STAFF REPORT
KETCHUM PLANNING AND ZONING COMMISSION
REGULAR MEETING OF FEBRUARY 28, 2023

- PROJECT:** 691 N Spruce Avenue Residence
- APPLICATION TYPE:** Mountain Overlay Design Review (Application File No. P22-042B)
Lot Consolidation Preliminary Plat & Waiver (Application File No. P22-042A)

- PROPERTY OWNER:** Spruce and 6th LLC
- REPRESENTATIVE:** Jake Watkins, Roger Ferris + Partners (Architect)
- REQUEST:** Final Mountain Overlay Design Review and Lot Consolidation Preliminary Plat with Waiver Request for the development of a new 4,534-gross-square-foot one-family dwelling

Figure 5: Glass Windows and Doors & Wood Louvers (Sheet G002)

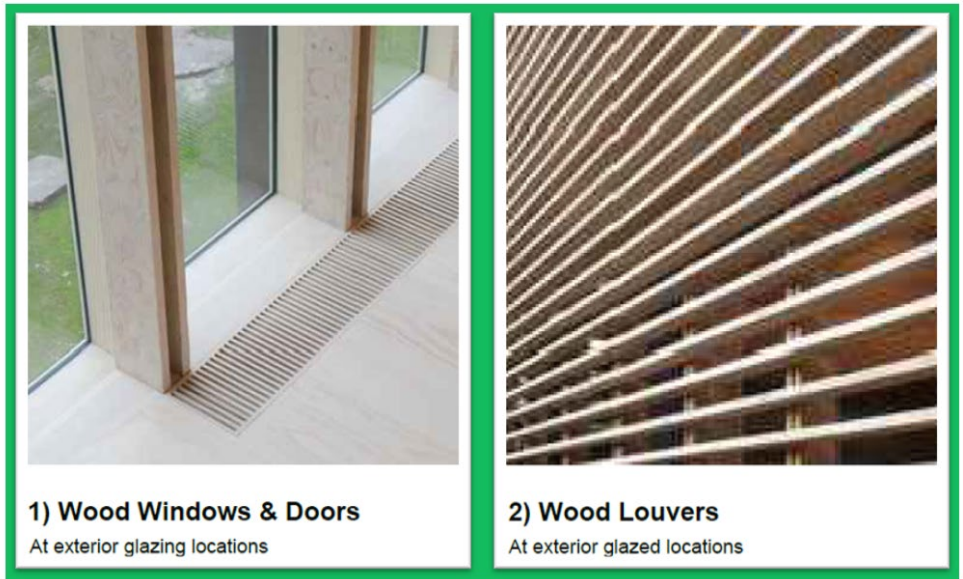
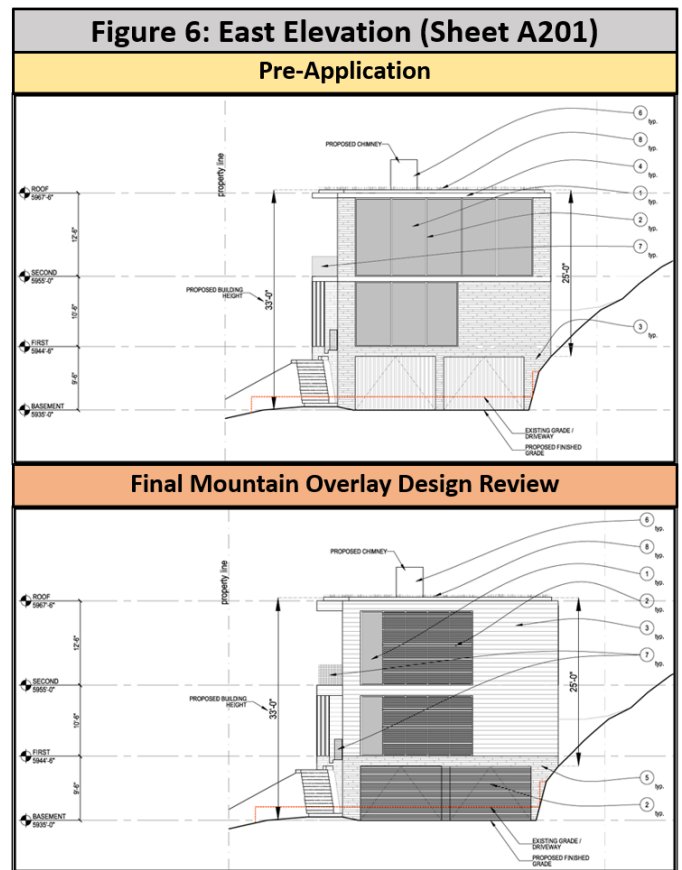
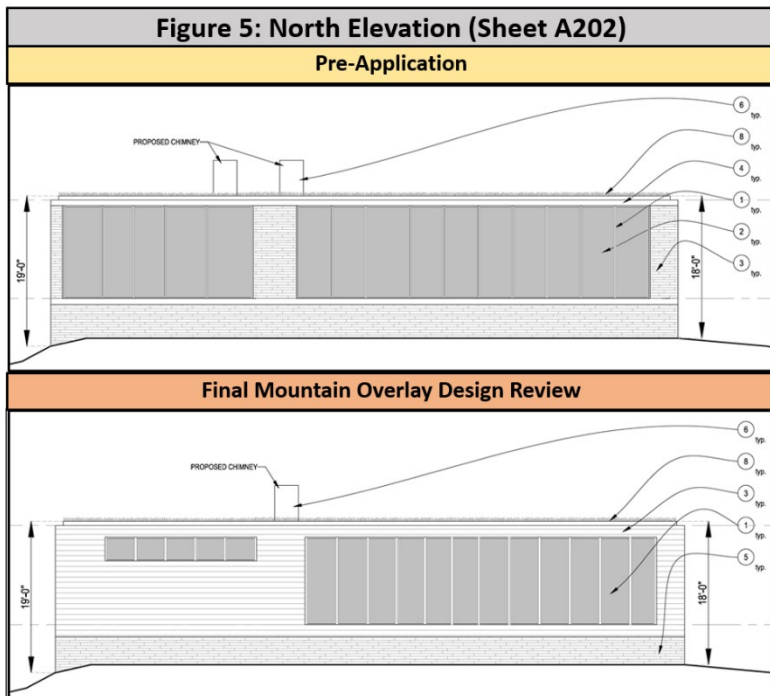
- 1) *We have reduced the amount of glazing on the northern and eastern facing facades.*
- 2) *We have introduced wood louvers on the eastern façade. These will reduce the light trespass of the glazed surfaces behind them by approximately 50%.*
- 3) *We will install a film on all glazed surfaces which will reduce the light transmittance of the glazing.*

Figures 5 and 6 provide a comparison showing the north and east elevations as proposed with the Pre-Application and with the design changes proposed with the final Mountain Overlay Design Review.

During department review, planning staff requested the applicant provide more information on the proposed film, including the percent reduction in light trespass that will be achieved through this treatment. Staff also recommended the design team consider reducing glazing at the south-facing wall to further minimize light trespass as most of this façade is comprised of glass windows and doors. The applicant did not provide additional information on the film or change the design of the south façade.

Staff recommends the Commission consider the applicant's proposed changes and current project design to determine if their response has sufficiently addressed the Commission's concerns about light trespass emanating from the home and associated disturbance to wildlife.

PROPOSED SITE GRADING AND DRAINAGE PLAN
691 NORTH SPRUCE
 LOCATED WITHIN SECTION 18, T. 4 N., R. 18 E., B.M. CITY OF KETCHUM, BLAINE COUNTY, IDAHO
 PREPARED FOR 891 NORTH SPRUCE LLC
 PROJECT INFORMATION
 P:\projects\2023\2023-01-10-891 North Spruce_IDAHO.dwg 01/11/23 11:34 AM

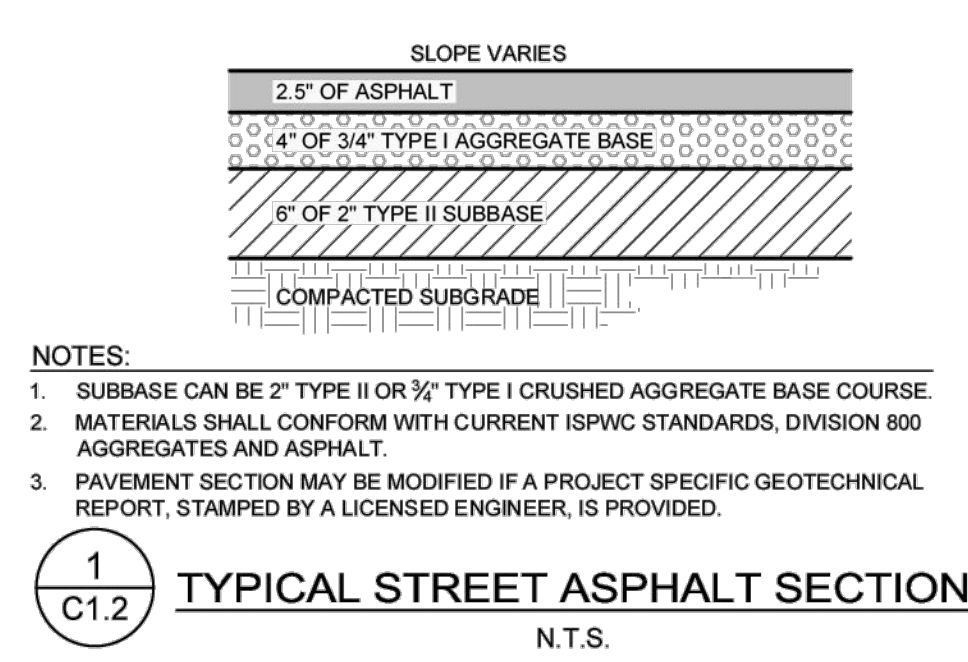
2. Comment: The site grading and drainage plan on Sheet C1.1 doesn't specify the proposed contour intervals for the driveway-grading improvements.

3. Comment: The site grading and drainage plan on Sheet C1.1 shows that a new infiltration gallery (Note SO6) is proposed to be installed along the full length of the south side-yard setback area. The civil notes and details on Sheet C1.2 do not provide specifications for the proposed infiltration gallery.

4. Comment: The landscape plan on Sheet L2.0 specifies that the driveway will include a snowmelt system. In addition, Sheet L2.0 shows that two snow storage areas will be provided on site and includes a note stating that snow will be hauled off site if needed. The engineered plans on Sheets C1.1 and C1.2 show that a new asphalt driveway will be constructed. The civil drawings do not specify that the driveway will include a snowmelt system. Per our phone conversation on January 5th, 2023, the driveway will include a snowmelt system. Pursuant to Ketchum Municipal Code §17.96.060.H4, snowmelt is permitted in lieu of providing snow storage areas on site. The on-site snow storage areas and snow hauling are not required as the driveway is proposed to include a snowmelt system.

5. Comment: The grading and drainage plan on Sheet C1.1 indicates that in addition to removing the existing nonconforming retaining walls on the subject property, the portion of the retaining wall that extends into the Spruce Avenue public right-of-way will also be removed. During our phone conversation on January 5th, 2023, you clarified that the entirety of the existing retaining wall that borders the dead end of Spruce Avenue is proposed to be removed.

- Required Action: Since the retaining wall bordering the dead end of Spruce Avenue is proposed to be removed, the proposed grading and drainage plan on Sheet C1.1 must be revised to specify how the finished grade proposed for the driveway access will tie into the existing grade of the hillside above the street.

- **Required Action:** Please add the proposed amount of cut and fill in cubic yards to the site grading and drainage plan on Sheet C1.1.

The proposed contours are shown on the driveway. We clarified this with Abby Rivin (P&Z staff) and Robyn Mattison (City Engineer) on a conference call held on Friday, Jan. 13th. See sheet C1.1 by Galena Engineering.

Details have been added. We reviewed this with Abby Rivin (P&Z staff) and Robyn Mattison (City Engineer) on a conference call held on Friday, Jan. 13th. See sheets C1.1 & C1.2 by Galena Engineering.

The snowmelt system location and area have been indicated on the plans. See sheet C1.1 by Galena Engineering.

The cut and fill figures have been added to the plans. See sheet C1.1 by Galena Engineering.

LANDSCAPE PLAN
RESIDENCE
 691 N. SPRUCE AVE, KETCHUM, IDAHO

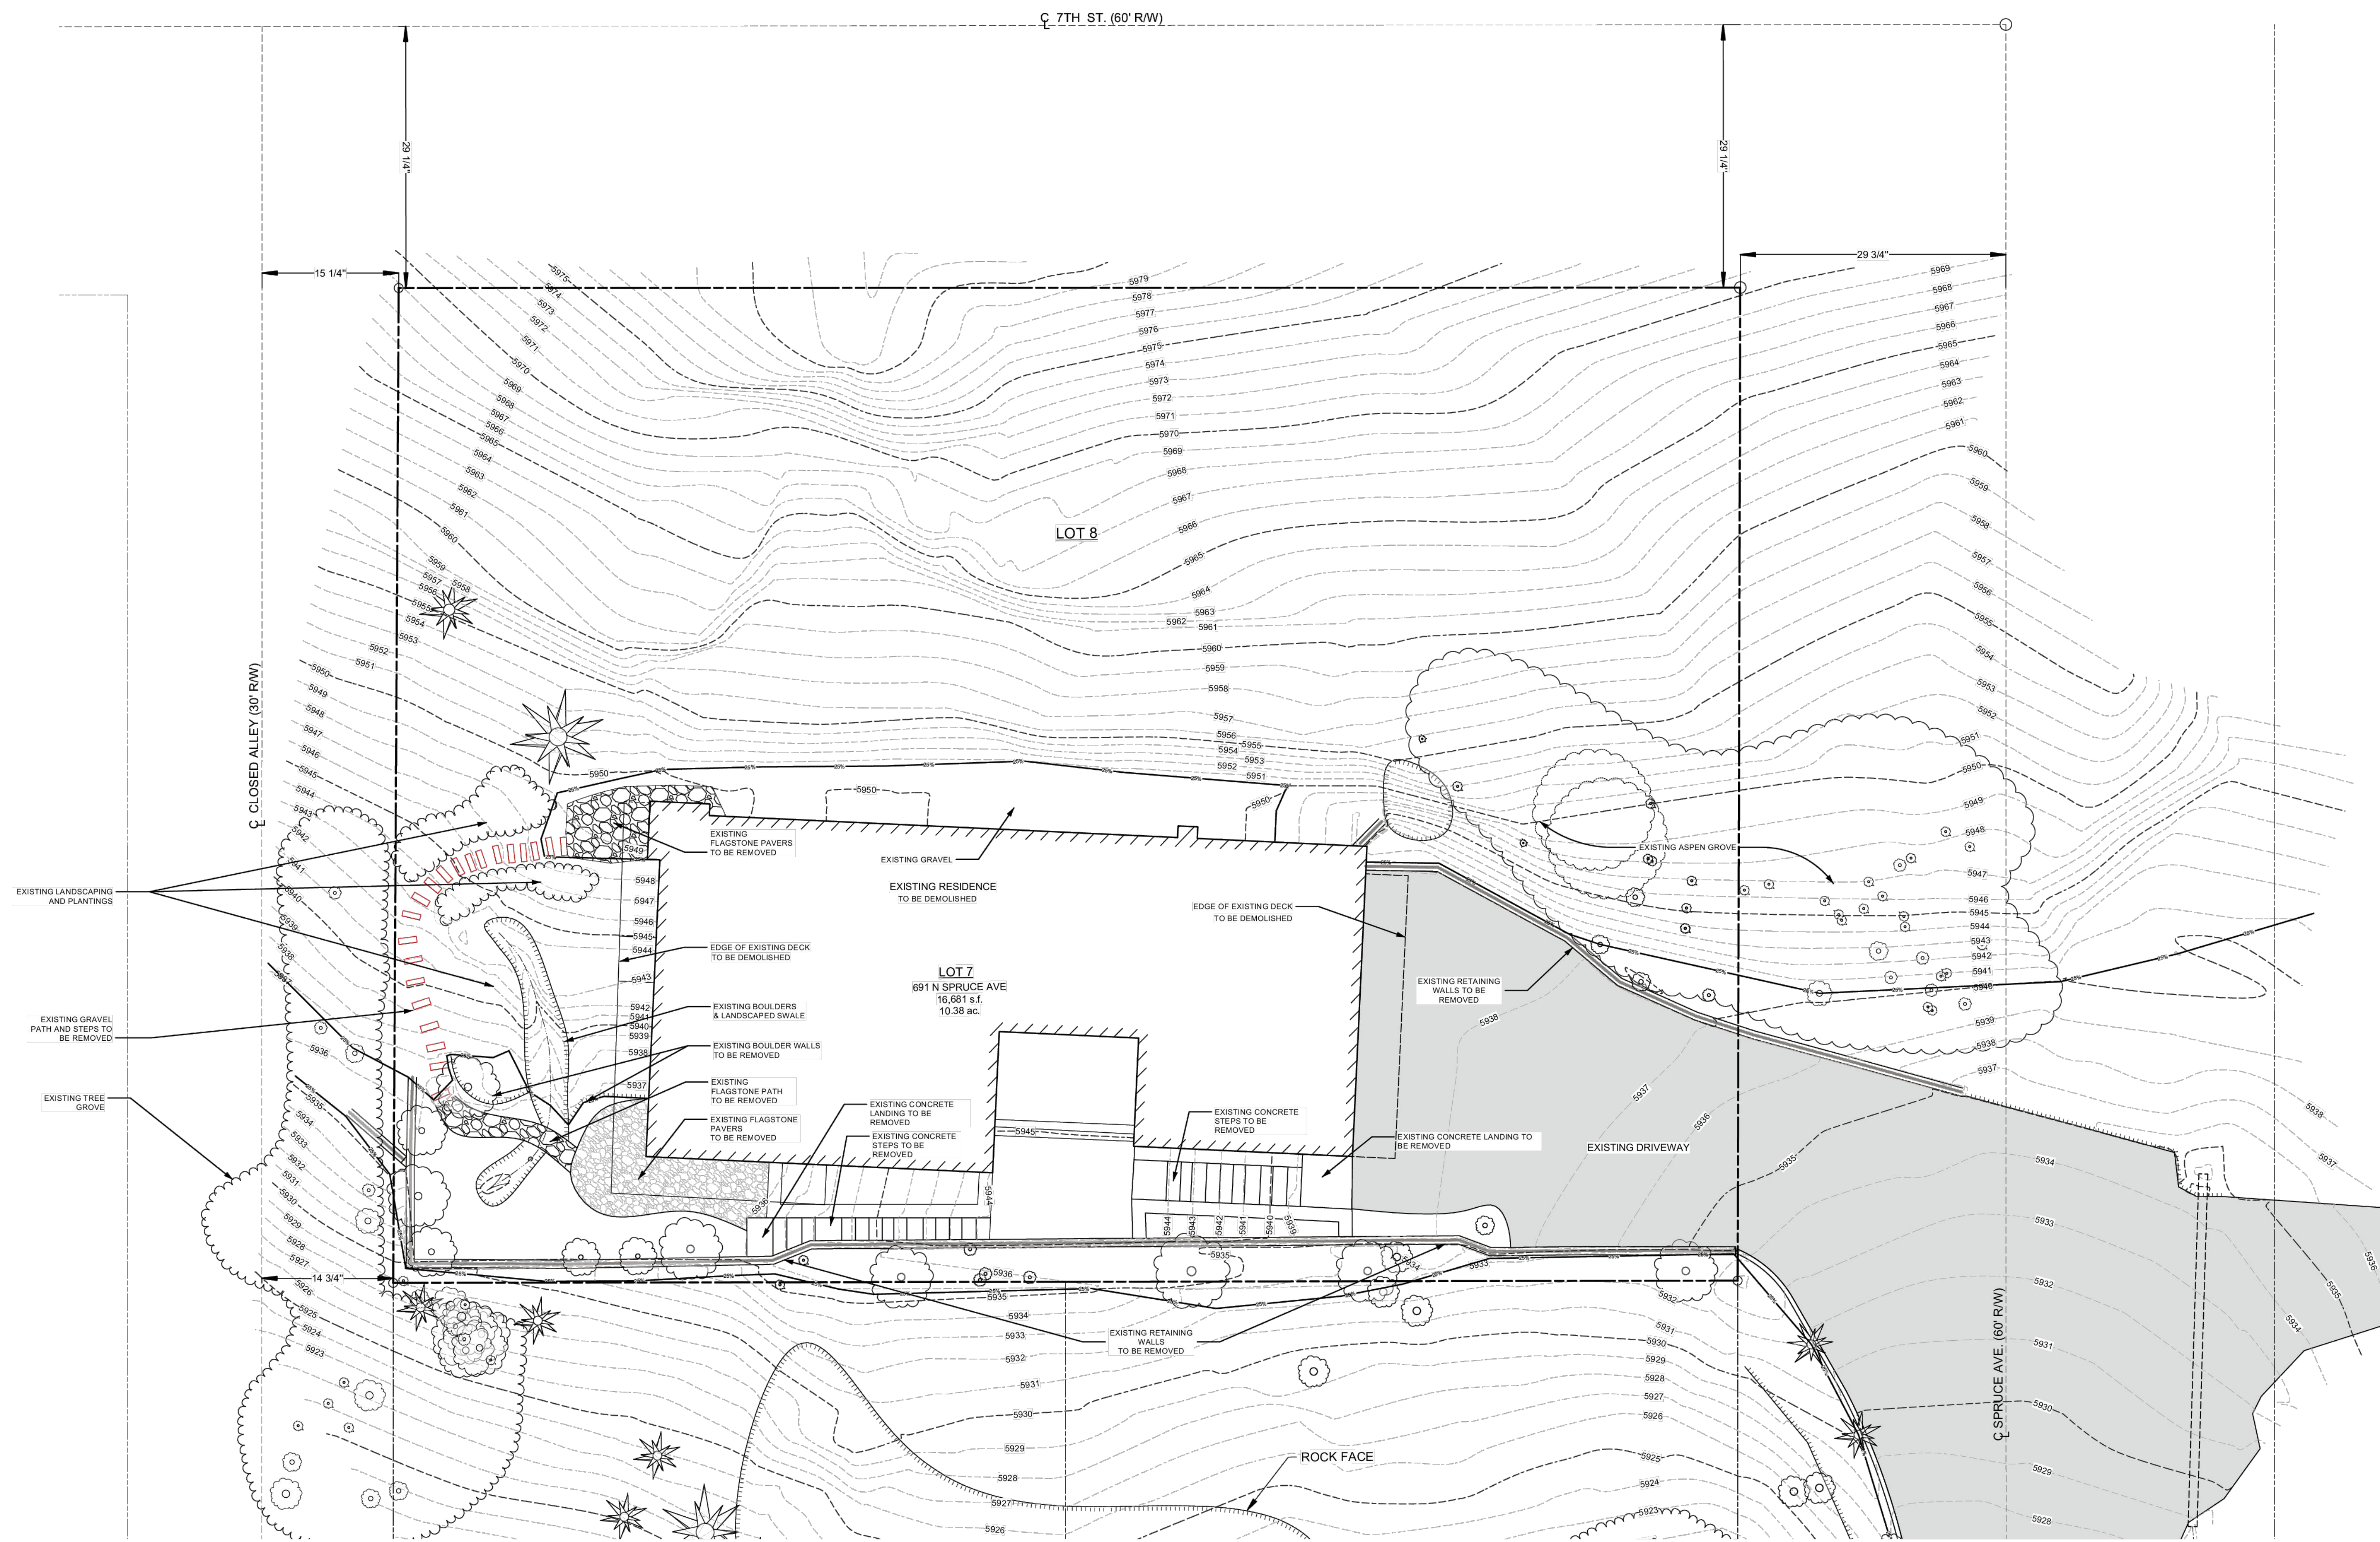
- Required Action: Please resolve the discrepancy between the civil and landscape drawings and revise the civil plans to specify the location and dimensions of the heated driveway area and snowmelt system. As on-site snow storage areas and snow hauling are not required per Ketchum Municipal Code §17.96.060.H4, Staff recommends that you remove these from the snow storage plan indicated on Sheet L2.0.

8. **Comment:** The landscape plan on Sheet L2.0 includes a picture illustrating the design concept proposed for the entry stairs. The picture shows stone treads separated by grass. The entry stairs proposed for the project are comprised of railroad ties that form risers along a gravel pathway.

- **Staff Recommendation:** Staff recommends that you add a note to Sheet L2.0 clarifying that the picture is an illustrative example of the design concept to minimize confusion for the public and Planning and Zoning Commission.

The landscape plans have been revised to comply with Fire Department requirements for clearance around the home. Please see updated sheet L2.0 prepared by BYLA.

The snow storage areas and snowmelt system indicated on the landscape plan have been removed. See sheet L2.0 by BYLA.

A note has been added indicating that the image is for design intent only. See sheet L2.0 by BYLA.
